SEWAGE DISPOSAL SYSTEM

DEPARTMENT OF HEALTH AND MENTAL HYGIENE

SUBDIVISION Woodford's Grant LOT X 35 ROAD 11376 Barley Field Way

SITE INSPECTION SHEET

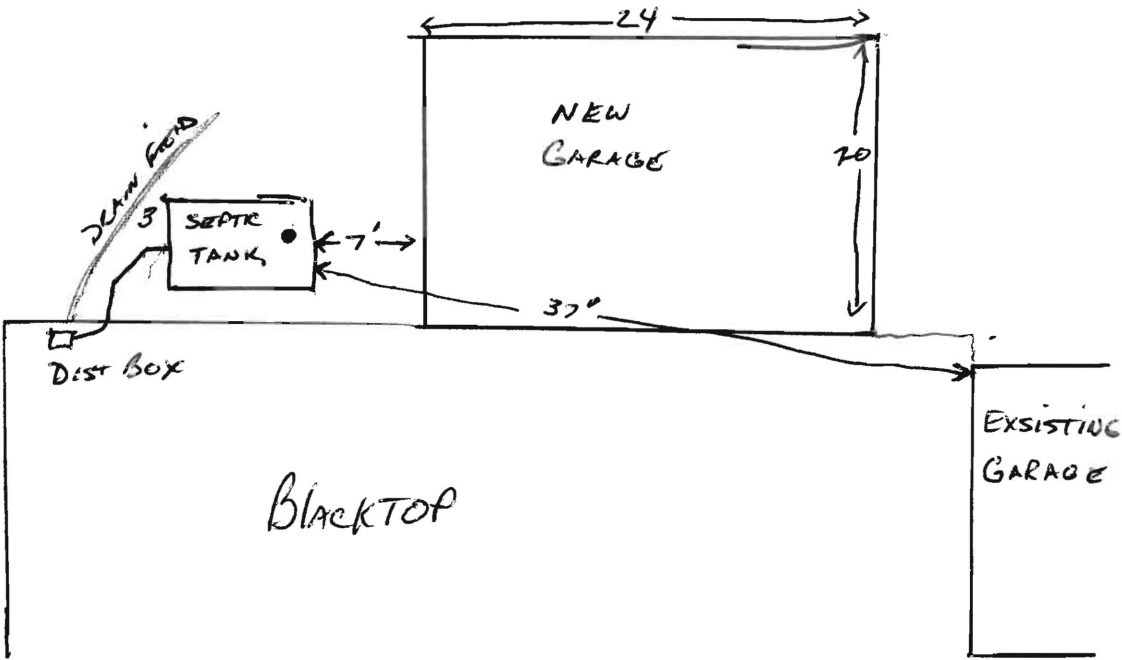
REMARKS: 7/21/99 If contractor comes out of house as specified on BP plan - it will be out of the ground - told him to lower system 1 foot - also move DB 10' so the 60' trenches could be run in both directions (SRW)
7/21/99 - OK TO CONTINUE WORK (SRW)
7/21/99 - OK TO COVER ALL WORK, HOUSE CONNECTION STILL NEEDED (SRW)
7/26/99 NO HOUSE CONN; DRIVEWAY INSTALLED OFF COMMON DRIVE (MR)
11/12/99 House connection confirmed (CW)

LOCATION DIAGRAM

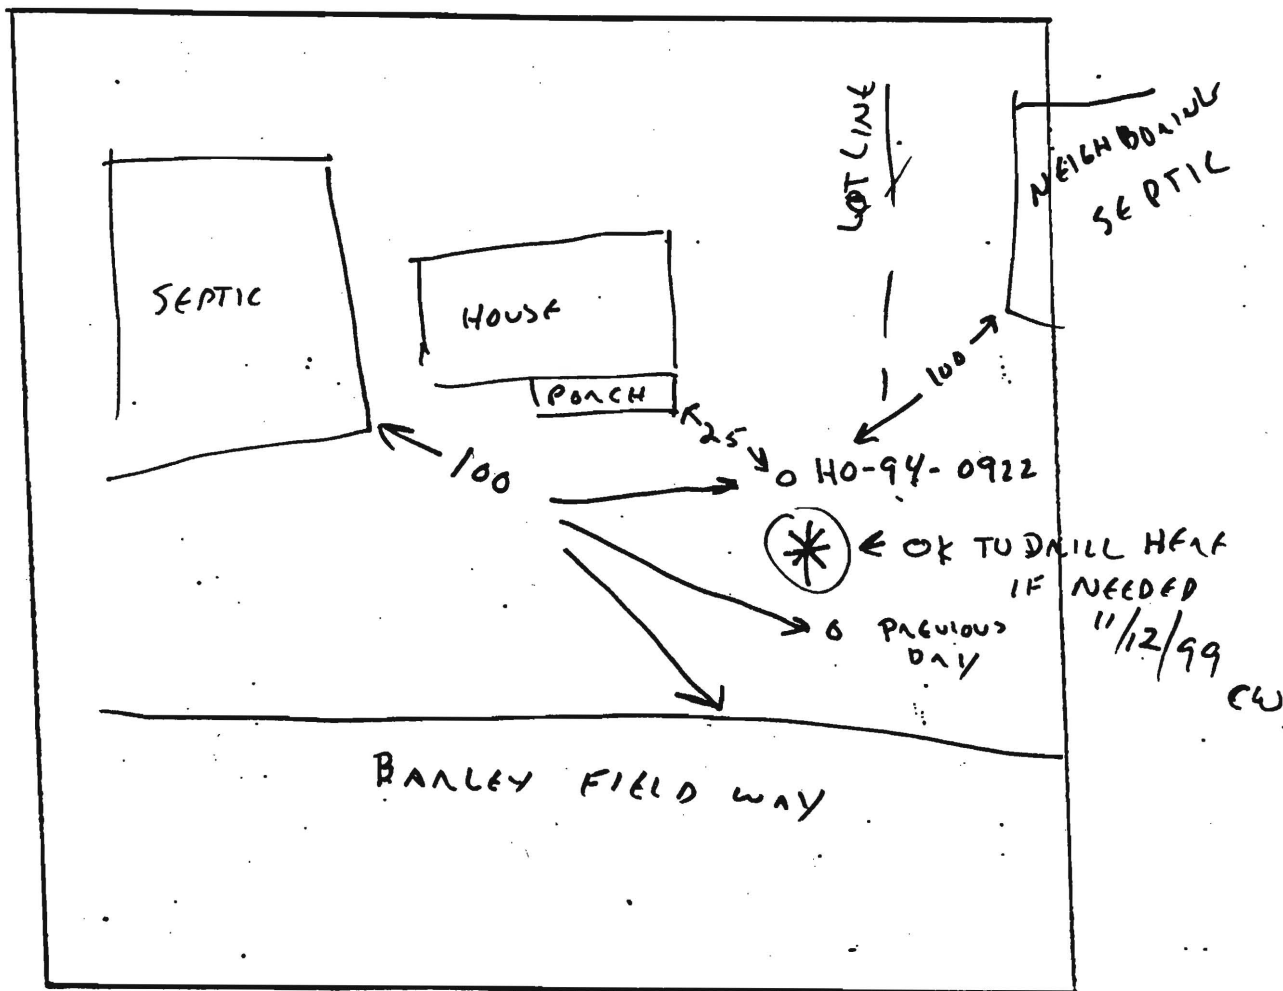
PROPOSAL: BUILDER REPORTS WELL CONSTRUCTION PROBLEMS DISCOVERED

ONE WEEK BEFORE SCHEDULED OCCUPANCY.

COMMENTS: ONLY REMAINING LOCATION TO DRILL APPEARS TO BE MIDWAY BETWEEN EXISTING WELL AND PREVIOUS DAY HOLE.

WILL EVALUATE EXISTING WELL FOR POTENTIAL RECONSTRUCTION BEFORE COMMITTING TO DRILL (APPLICATION NOT YET FILED)
